NOTICE OF PLAN COMMISSION MEETING

DATE: Thursday, January 21, 2020
TIME: 5:30P.M
PLACE: Washburn City Hall

ARCHITECTURAL REVIEW & DOWNTOWN DESIGN DECISION

ARCHITECTURAL REVIEW & DOWNTOWN DESIGN DECISION

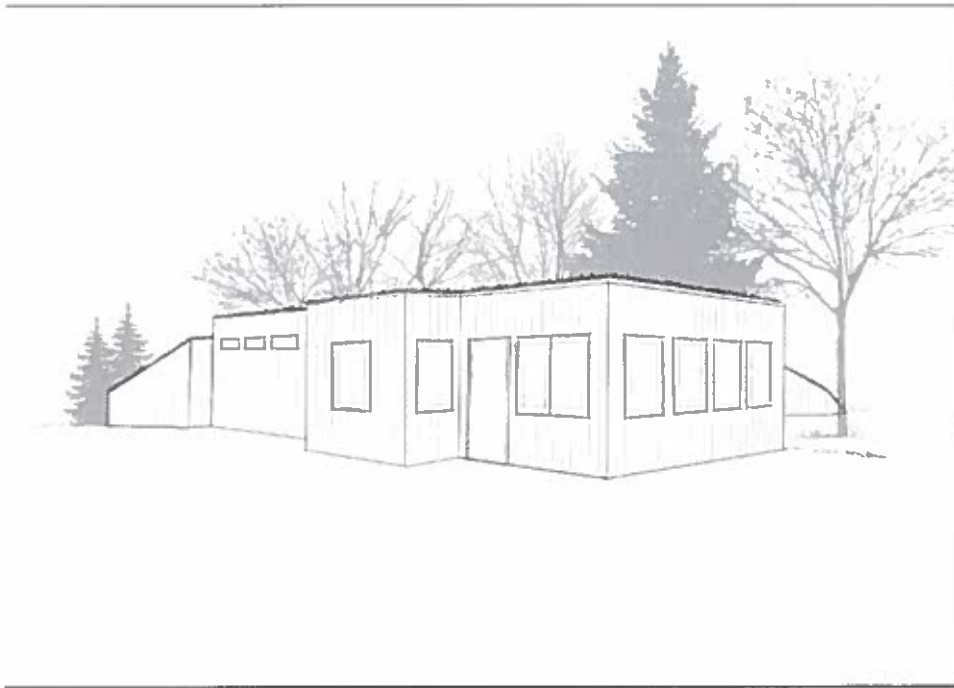
As for the architectural and downtown design review, the Plan Commission will need to determine if cedar siding will be an acceptable front exterior as the glass windows will be less than 50 percent of the front exterior. I am not aware of changes to HVAC systems or to trash/recycling. Any fencing should match as well. Besides that, I find the rest of the proposed changes to the building to meet with the standards.

- (1) Excluding residential buildings and Industrial Zoning Districts, all building exteriors facing a street, not including an alleyway, shall have at least 50 percent of the street face constructed with brick, decorative masonry, glass panel, or other appropriate similar finished façade as may be approved by the Plan Commission. Such brick, masonry, glass, or other decorative facing shall extend for a distance of at least 25 feet along the sides of the structure that do not face a street or at least 25 percent of the that side wall distance, whichever is greater. **The front exterior will have glass panel windows; however, it will not cover 50 percent of the street face. The remaining portion of the street face will be cedar, and the Plan Commission finds this to be an acceptable material.**

- (7) **Building materials.** Selected building materials shall be compatible with those of existing buildings in the immediate area which generally consist of natural materials such as stone, brick, and wood. Concrete masonry units, corrugated metal, half-log siding, and vinyl siding are prohibited. **The Plan Commission finds that this provision is met with the use of cedar siding.**

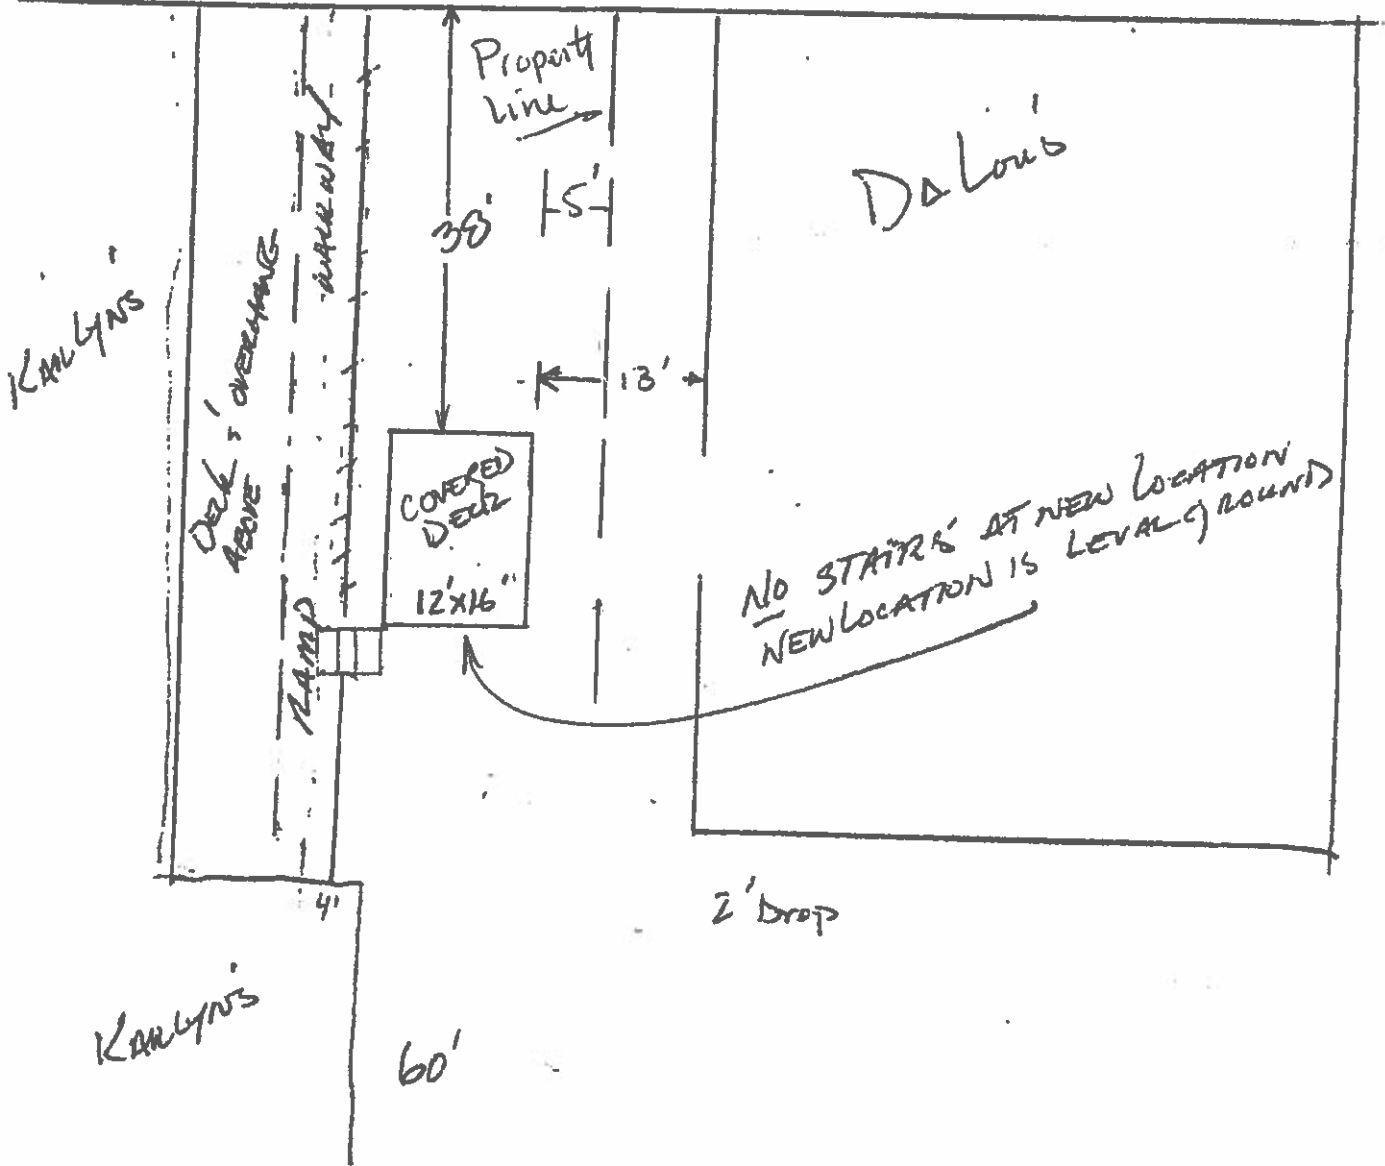
Karlyn Yellowbird Gallery - Enclosed you will find revised plans for an outdoor covered deck/pavilion for the site. The plan conforms to the required setbacks and the deck will be at ground level; however, you will note that the structure will have a pitched roof. The Plan Commission will need to decide if this is acceptable on an accessory structure. Please see the explanation provided from Mr. Piercy. In addition, please note that last time composite decking was proposed, but the structure would be made entirely of pressure treated wood this time. The Plan Commission is going to need to determine if horizontal rhythms are kept, I am not sure how to comment on that item at this time.

This structure will be built at a 5 foot setback from the property line and 13 feet from the neighboring building. Please reference the plan view lot drawing.

4. List of Conditions Imposed: **The project will need to comply with the American Disability Act in relation to any requirements for ramp access to the deck. (This time the deck is proposed to be a ground level with no stairs.)**

SHEET NUMBER
S-5-CB
SCALE: 1/4"=1'-0"

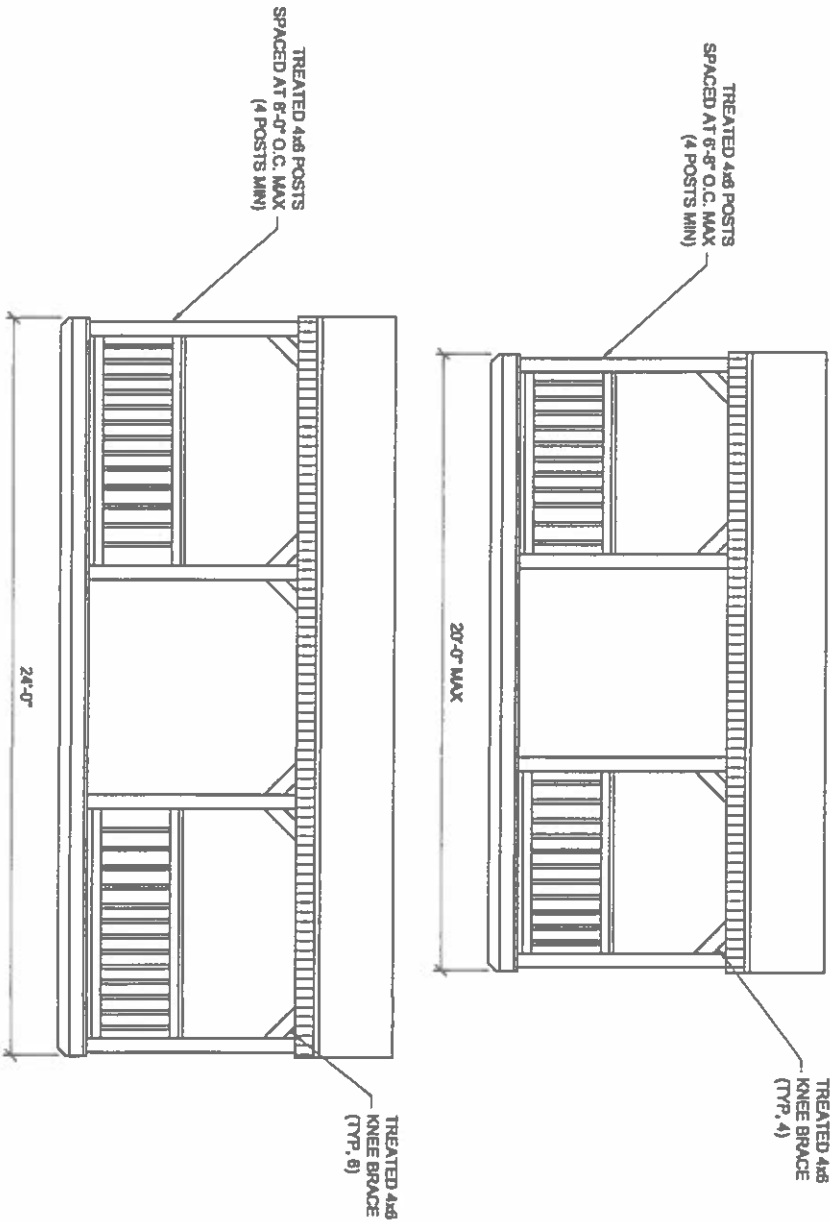
- (5) **Roof forms.** Flat or gently sloping roofs which are not visible from the street grade shall generally be used. Mansards or other exotic roof shapes are not characteristic of the district's character and are prohibited. **This structure would have a pointed roof.**

This building is designed and built to the Wisconsin Snow=60PSF-IBC2015 requirements. Please see structural drawing elevations.
